## V2500-D5 SERIES PROPULSION SYSTEM SERVICE BULLETIN

This document transmits Revision 1 to Service Bulletin EV2500-72-0464 and Revision 1 to the Supplement

# V2500-ENG-72-0464

NEW FIRST STAGE BLADE OUTER AIR SEAL AND HPT VANE SUPPORT (CONTROLLED SERVICE USE)

LOCATION OF THE STAGE 1 HIGH PRESSURE TURBINE SUPPORT ASSEMBLY  
FIGURE 1

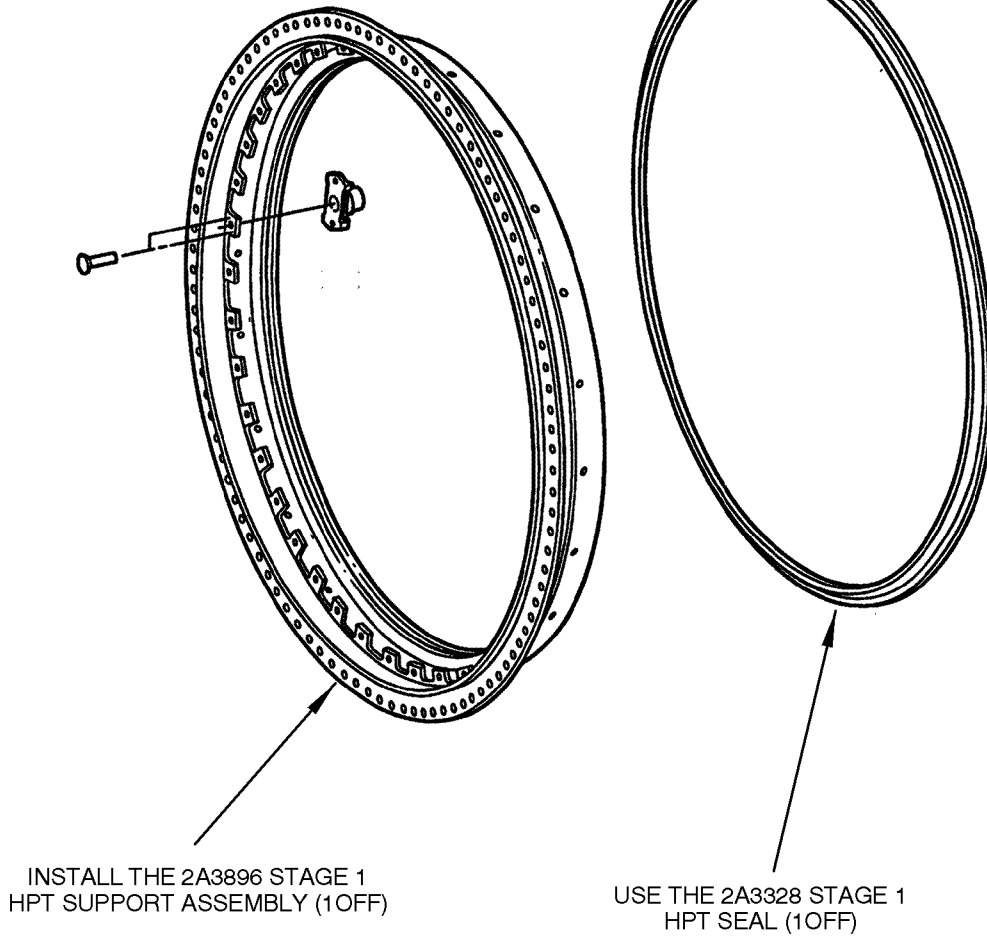
- (a) Do a modification of the 2A2703 or 2A3367 Stage 1 HPT Vane Support (1 off). See Reference (12), Chapter/Section 72-44-10, Figure/Item No. 01-010. See Figure 2.
  - (i) Remove the 1st stage HPT Seal PN 2A3328. See Figure 1.
  - (ii) It is recommended that the Nut PN 743645 (40 off) be removed to avoid damage to the Nut during modification.
  - (iii) Enlarge hole 'F' 20 places. in Stage 1 HPT Vane Support 2A2703 or 2A3367 . See Figure 2
- (b) Mark the new part numbers on all affected parts per the Reidentified Parts section. See reference (13) Standard Practices/Process Manual.
